Re: Final Report
Groundwater Budget and Approach to a Groundwater Management Plan,
Upper and Lower Ventura River Basin

Groundwater Budget and Approach to a Groundwater Management Plan Upper and Lower Ventura River Basin

Appendix B
Response to Comments

DRAFT Groundwater Budget and Approach to a Groundwater Management Plan, Upper and Lower Ventura River Basin (75% Complete), dated August 20, 2010

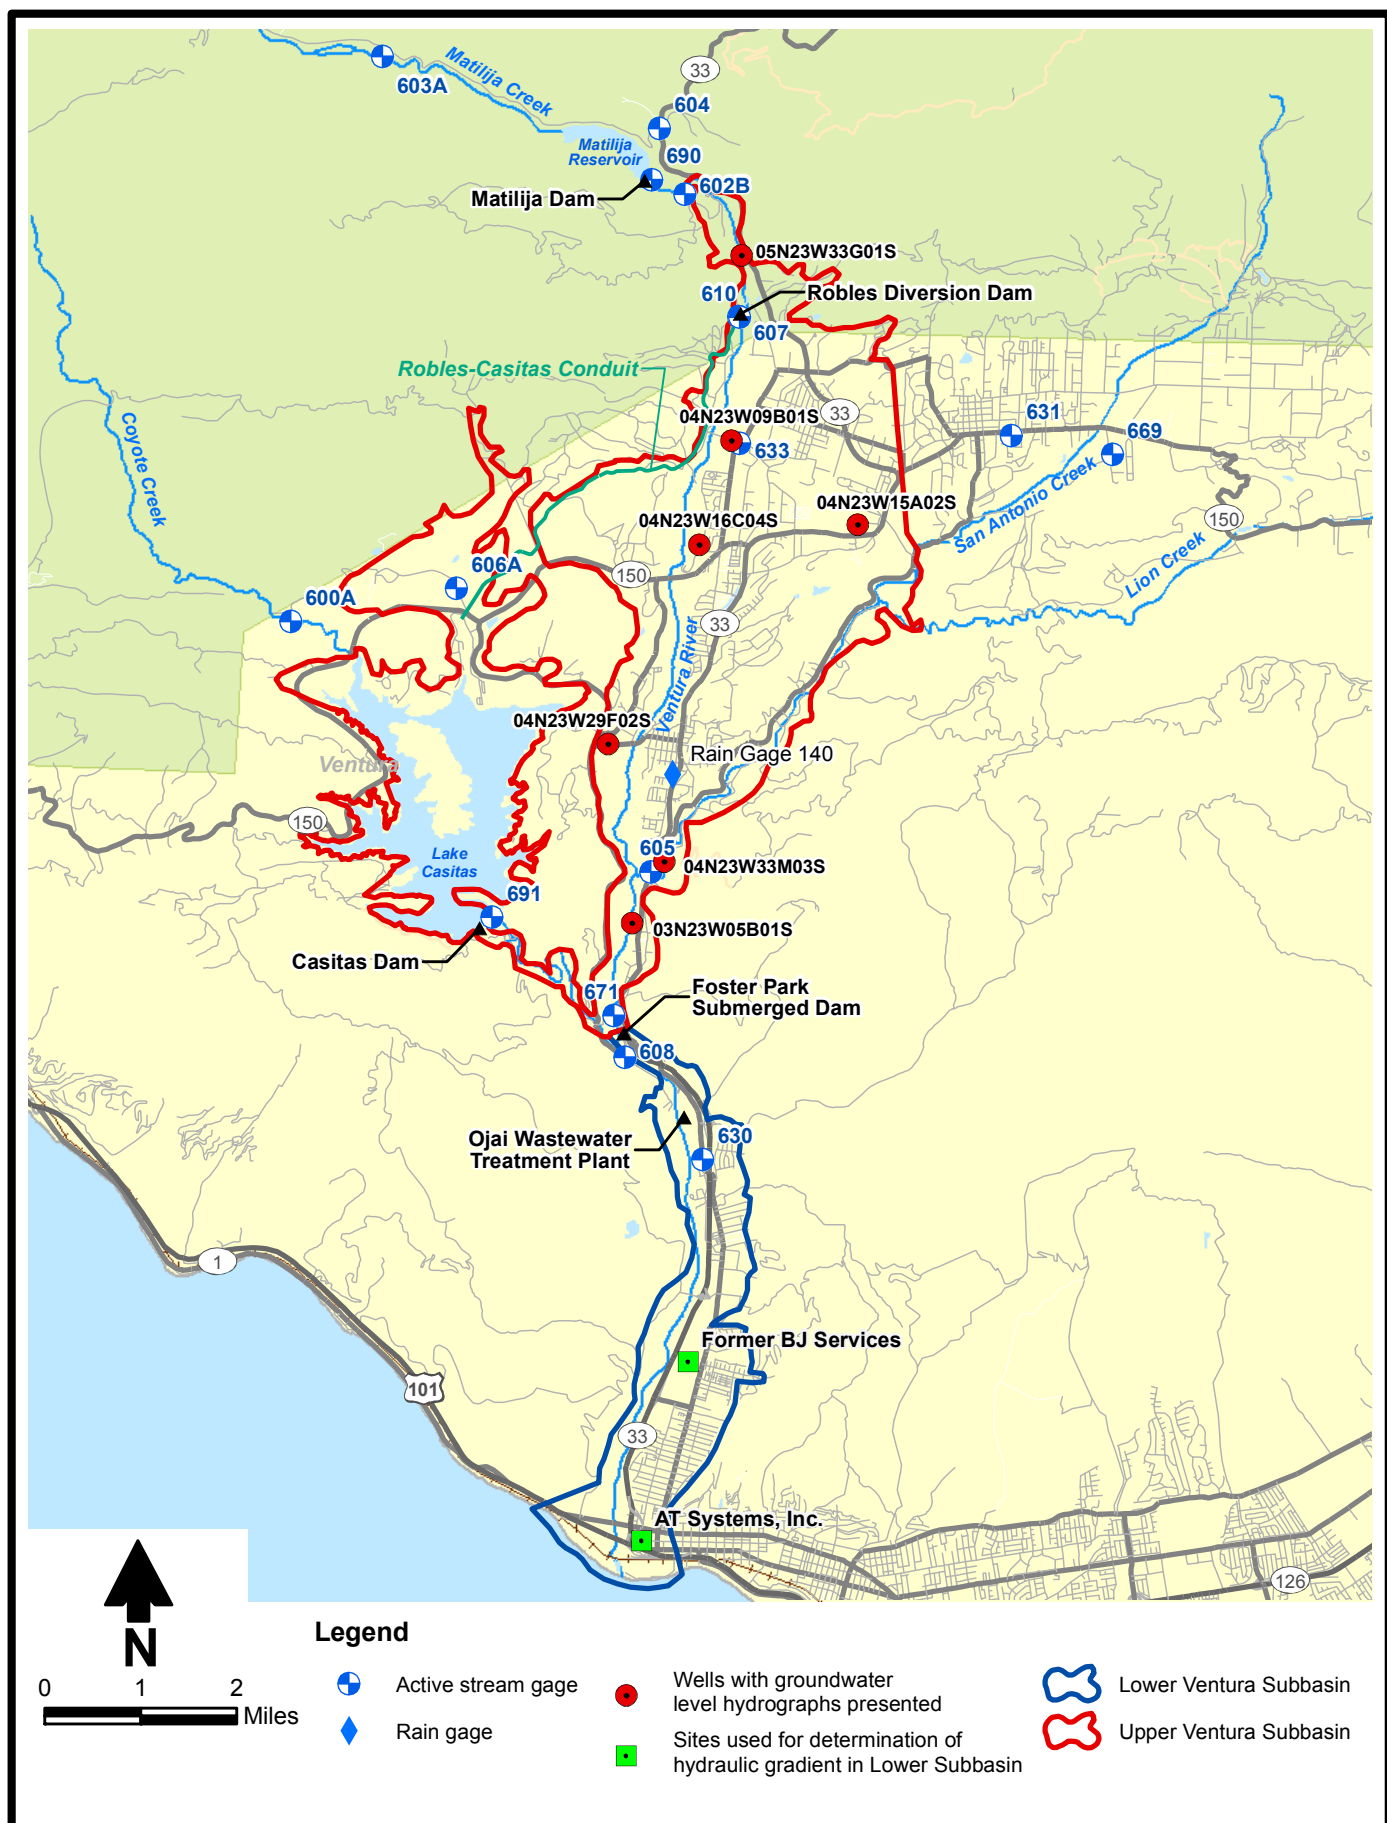
25. *Figure 1 - Figure 1 does not show all items described on Page 2 middle paragraph of report. Given the scale it might be difficult. If all items cannot be included on the map as shown, please print figure on larger paper or split figure and put Upper and Lower basins on separate pages.*

All items listed in this paragraph are now shown in Figure 1.

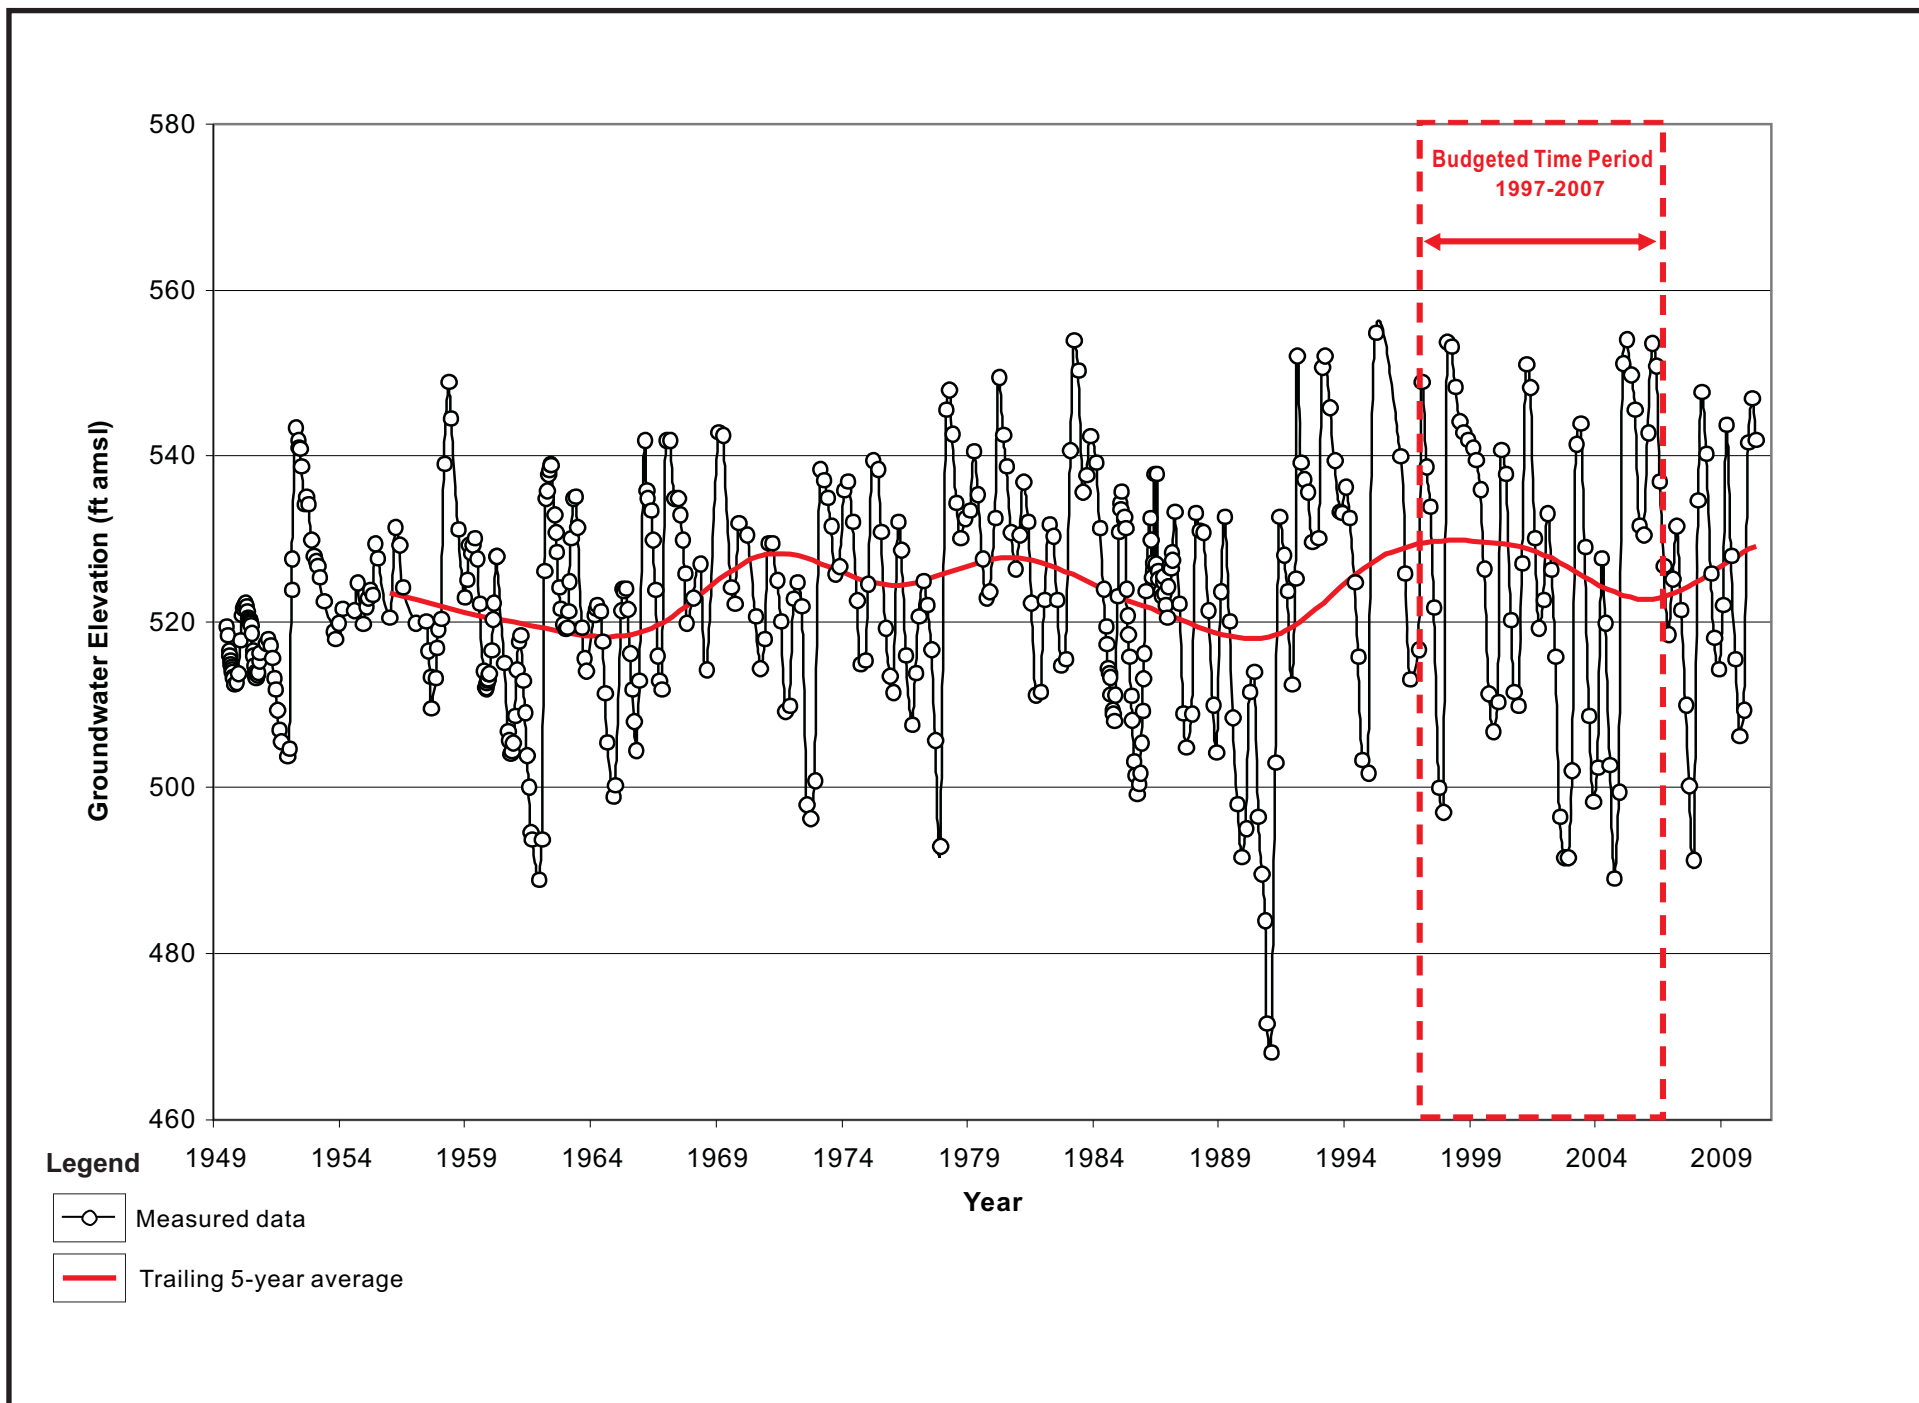
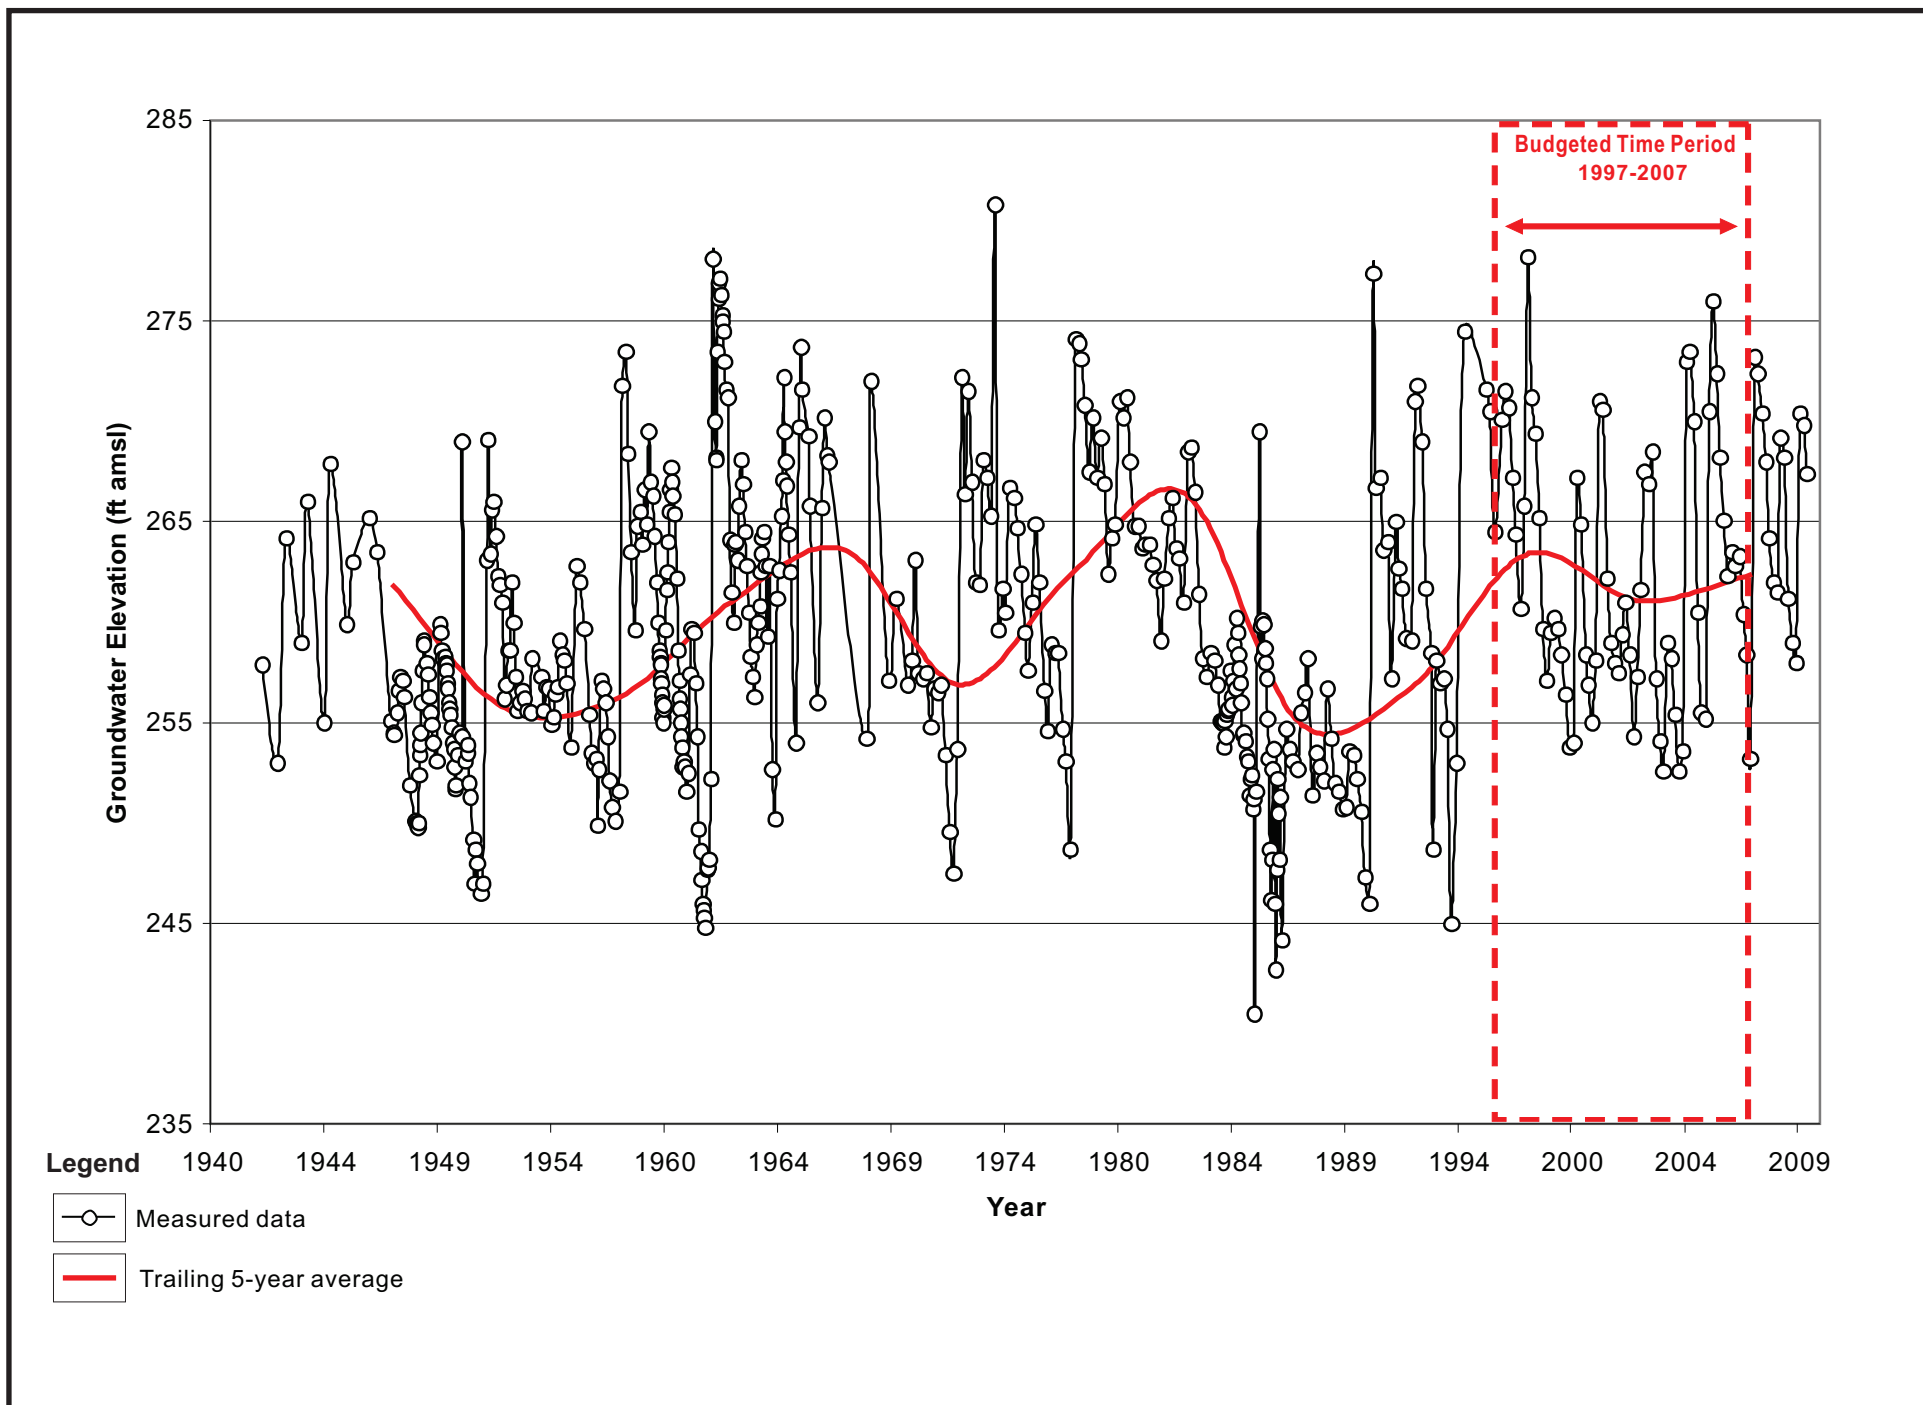
26. *Figure 2 - Figure 2 is used to support the concept that overall water levels have remained stable in the basin, but one of the concluding tables in the report shows a net deficit of around 2000 acre feet per year. This appears internally inconsistent. Please include an explanation.*

The discussion regarding comparison of hydrographs and the results of the budget has been revised.
